OFFICIAL STAR CLASS MEASUREMENT CERTIFICATE

YACHT NO. 3320

Star No 3320

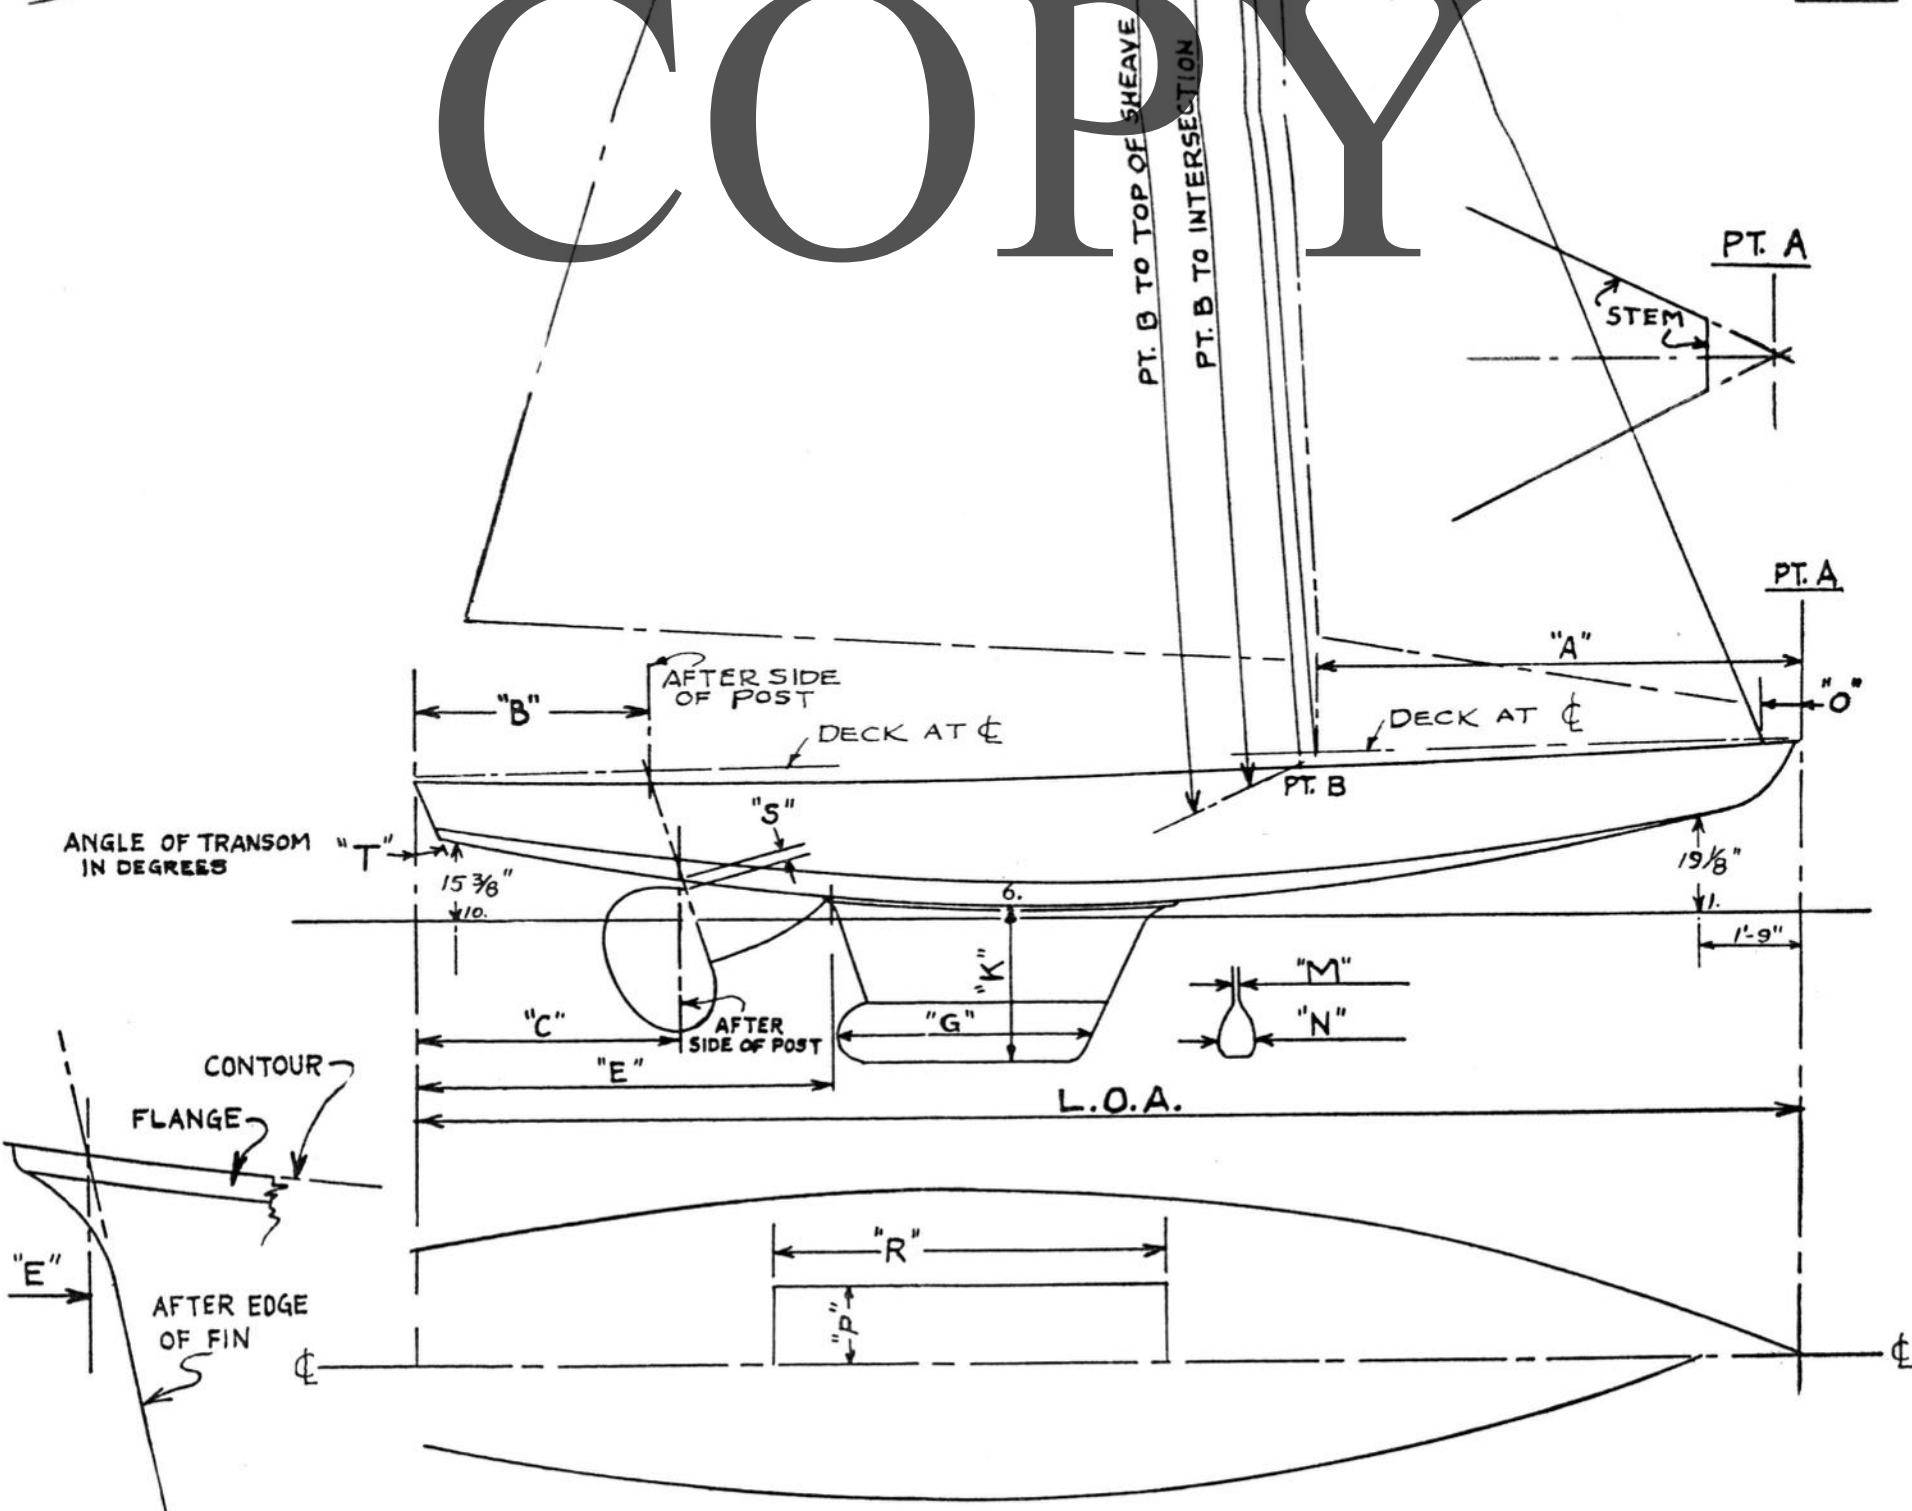
Correction per letter July 27, 57

According to Your letter , with stamp dating June 29 1955, will I inform You that the dimension A has been measured in metre to 2,260 m. and by figuring to feet has been wrong. The same is done with side height, station 1, measured to 0,339 m.
